# Access Compliance Report

## Public Rights-of-Way

Intersection ID: 53713	Main Street: N_TRYON_ST	Cross Street: PERIWINKLE_HILL_AV	Location: S
ADA ID: 7BC213331E0A	Ramp Type: Perp	Initial Pass/Fail: Fail	Overall Compliance: No
Severity Score: 21.25			
Codes/Mitigation Info/Possible Solution		Field Measurements/Component Compliance

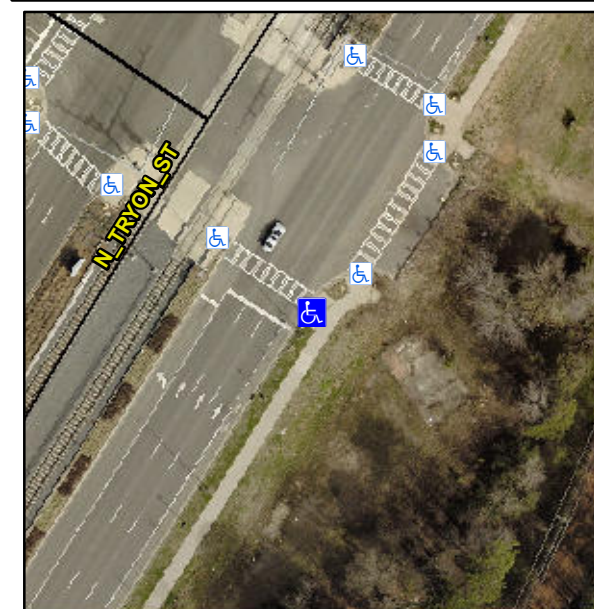
**Remove & Replace Entire Ramp.**

**R304.5.1, R304.2.2**

Compliance	Description	Data	Compliance	Description	Data
N/A	Ramp Length (in)	98.0	No	Ramp Slope (%)	8.4
No	Ramp Width (in)	46.5	Yes	Ramp XSlope (%)	1.1
N/A	Flare Type LT	N/A	N/A	Flare Type RT	N/A
N/A	Flare Slope LT (%)	N/A	N/A	Flare Slope RT (%)	N/A
N/A	Flare Traversable LT?	N/A	N/A	Flare Traversable RT?	N/A
N/A	Landing Length (in)	N/A	N/A	DWS Provided?	N/A
N/A	Landing Width (in)	N/A	N/A	DWS Contrast?	N/A
N/A	Landing Slope (%)	N/A	N/A	DWS Length (in)	N/A
N/A	Landing X Slope (%)	N/A	N/A	DWS Full Width?	N/A
N/A	Landing Curb? (Y/N)	N/A	N/A	DWS Offset (in)	N/A
N/A	Shared Landing?	N/A			
N/A	Gutter Ponding?	N/A	N/A	Gutter Slope (%)	N/A
N/A	Gutter Lip Ht (in)	N/A	N/A	Gutter X Slope (%)	N/A
N/A	Painted X Walk1?	Yes	N/A	Painted X Walk2?	N/A
	X Walk 1 Direction	To NW		X Walk 2 Direction	N/A
N/A	X Walk 1 Width (in)	106.0	N/A	X Walk 2 Width (in)	N/A
	X Walk 1 Slope (%)	1.3		X Walk 2 Slope (%)	N/A
	X Walk 1 X Slope (%)	1.1		X Walk 2 X Slope (%)	N/A
